# SERVICE CAMPAIGN BULLETIN

NTB98-073a

## VOLUNTARY SERVICE CAMPAIGN 1996 MAXIMA MALFUNCTION INDICATOR LIGHT (MIL) ISSUES

This amended version of NTB98-073 clarifies information in the Applied Vehicle, Introduction, Service Procedure (specifically steps A and F under "Water Separator Kit Installation Procedure") and Claims Information sections. Please discard paper copies of NTB98-073.

Figure 1

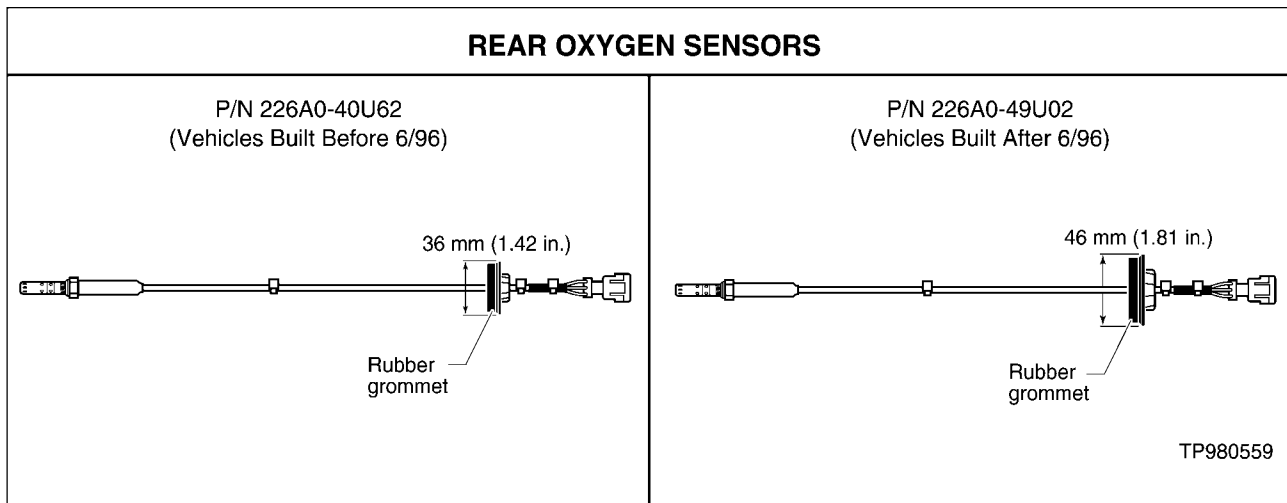
1. Determine the production date of the vehicle.
  - A. If the vehicle was produced before 6/96, install oxygen sensor kit P/N 22690-40U25 using the following steps.
  - B. If the vehicle was produced 6/96 or later, install oxygen sensor kit P/N 226A0-49U25 using the following steps.

**NOTE:** There is a difference between the rear oxygen sensors depending on the production date of the vehicle. The difference is the size of the rubber grommet (see Figure 1).

Figure 2

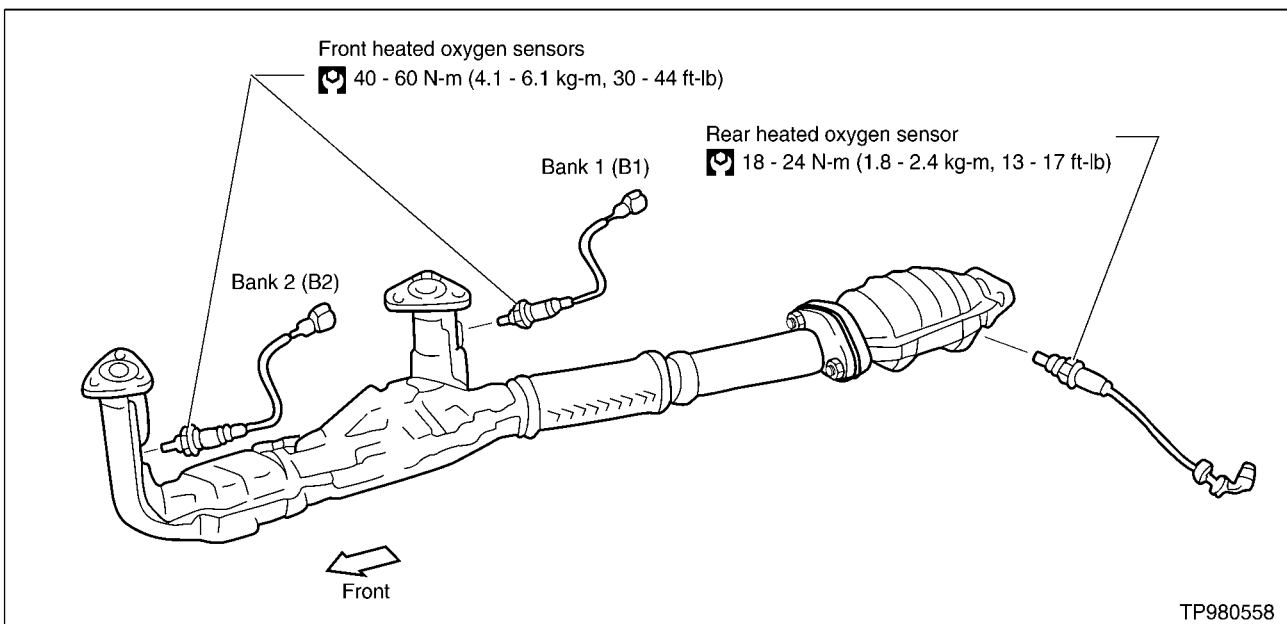
2. Install the new front and rear oxygen sensors (supplied in the kit) as follows:
  - A. Remove the two front (B1 & B2) and one rear oxygen sensors from the vehicle's exhaust system (see Figure 2).

- B. Install new oxygen sensors to the exhaust system (see Figure 2).
- C. Tighten the two front oxygen sensors to 40 - 60 N•m (4.1 - 6.1 kg-m, 30 - 44 ft-lb) and tighten the rear oxygen sensor to 18 - 24 N•m (1.8 - 2.4 kg-m, 13 - 17 ft-lb).

Figure 4

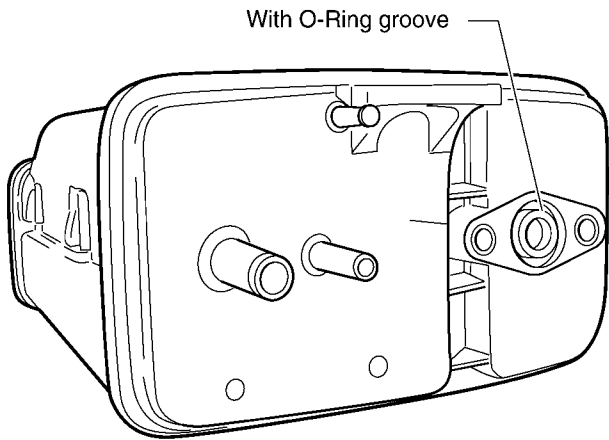
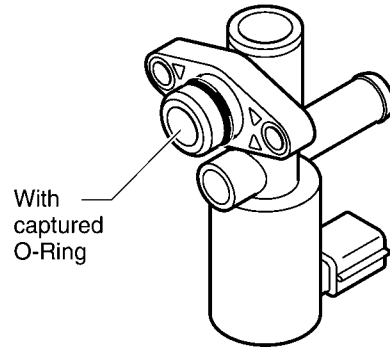
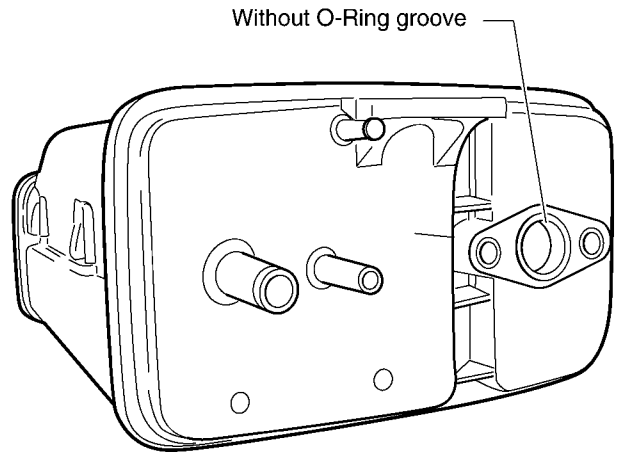
1. If the old EVAP vent control valve matches the “TYPE A” style valve (see page 7) replace it with valve P/N 14935-54U06.

2. If the old EVAP vent control valve matches the “TYPE B” style valve (see page 7) replace it with valve P/N 14935-54U04.

1. If the old canister matches the “TYPE A” style canister (see page 7), both the canister and vent control valve must be replaced as a set with “TYPE B” style components (canister P/N 14950-56U18, vent control valve P/N 14935-54U04).
2. If the old canister matches the “TYPE B” style canister (see page 7), replace it with canister P/N 14950-56U18.

**NOTE:** If the metal threaded inserts in the body of the EVAP canister become loose when removing the EVAP vent control valve mounting bolts, replace both the EVAP vent control valve and EVAP canister with “TYPE B” style components (canister P/N 14950-56U18, vent control valve P/N 14935-54U04).

**NOTE:** If the metal threaded inserts in the body of the EVAP canister become loose when removing the EVAP vent control valve mounting bolts, replace the EVAP canister with a “TYPE B” style component P/N 14950-56U18.

Figure 5

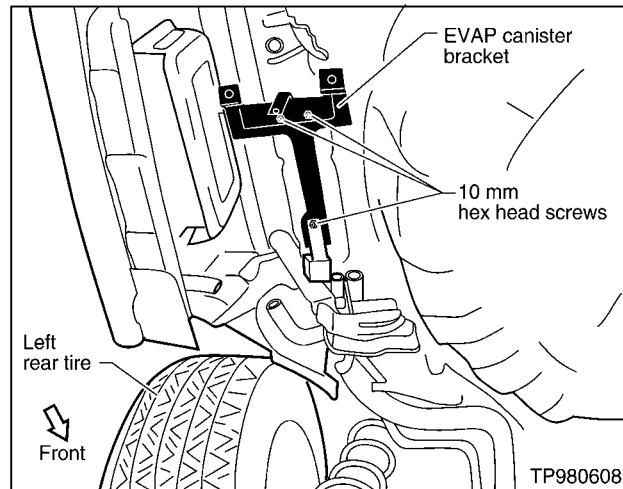
- A. Remove and discard the EVAP canister bracket ONLY (see Figure 5). Save the EVAP canister and bracket bolts for re-installation.

Figure 6

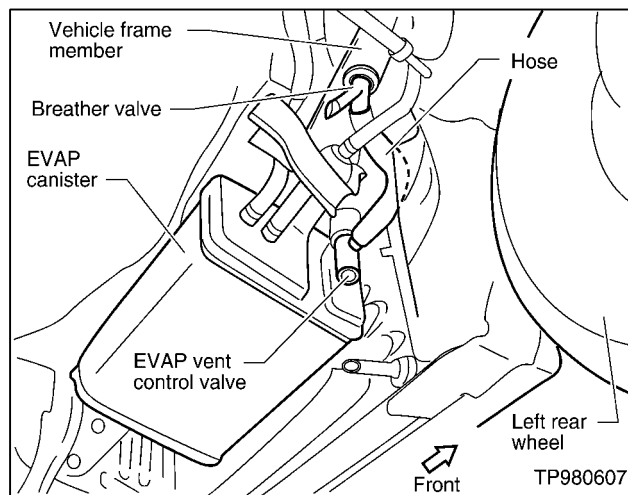
- B. Remove and discard the breather valve and hose (see Figure 6).

Figure 7

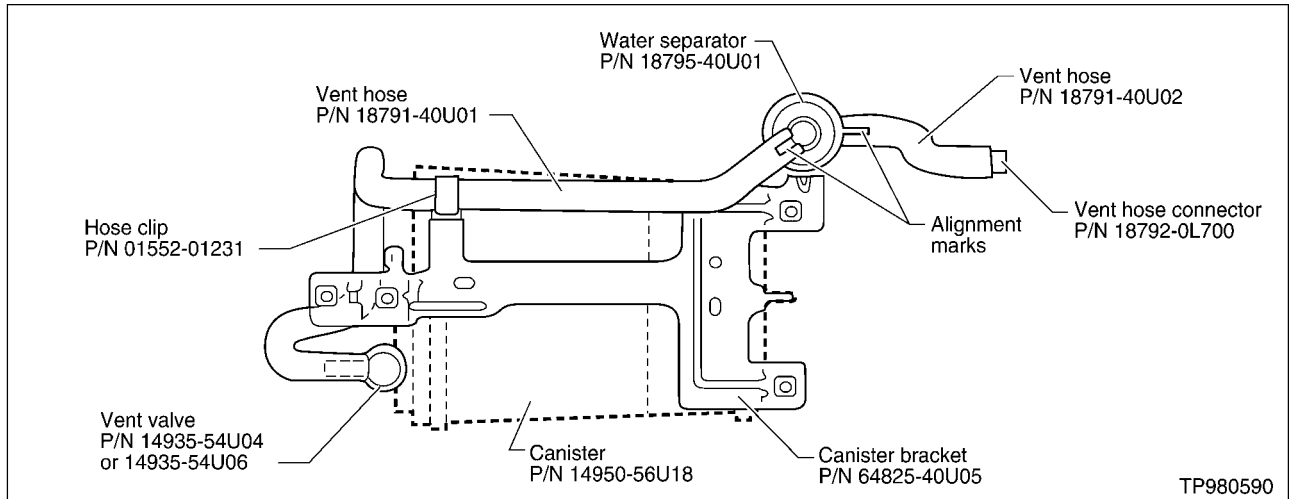
- C. Position the white alignment marks as shown to correctly assemble the new EVAP canister vent hoses, water separator and vent hose connector to the new EVAP canister bracket (see Figure 7).

Figure 8

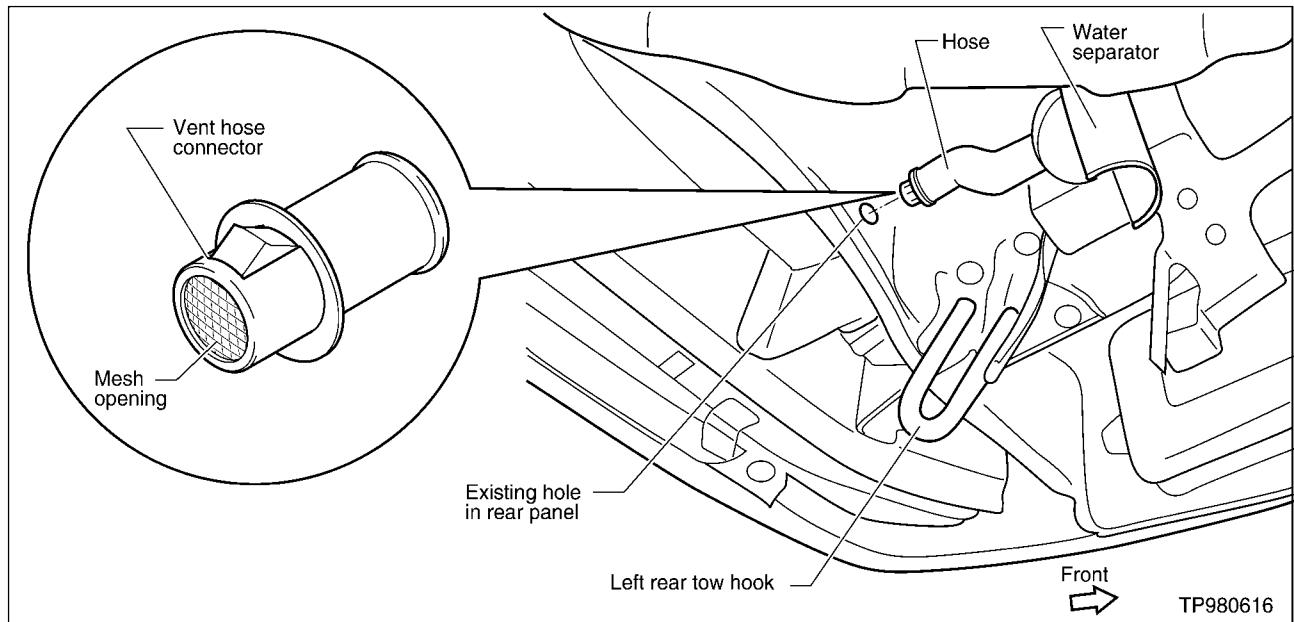
- D. Use the existing bolts and install the new canister bracket on the vehicle.
- E. Insert the vent hose connector into the existing hole in the vehicle rear panel (see Figure 8).
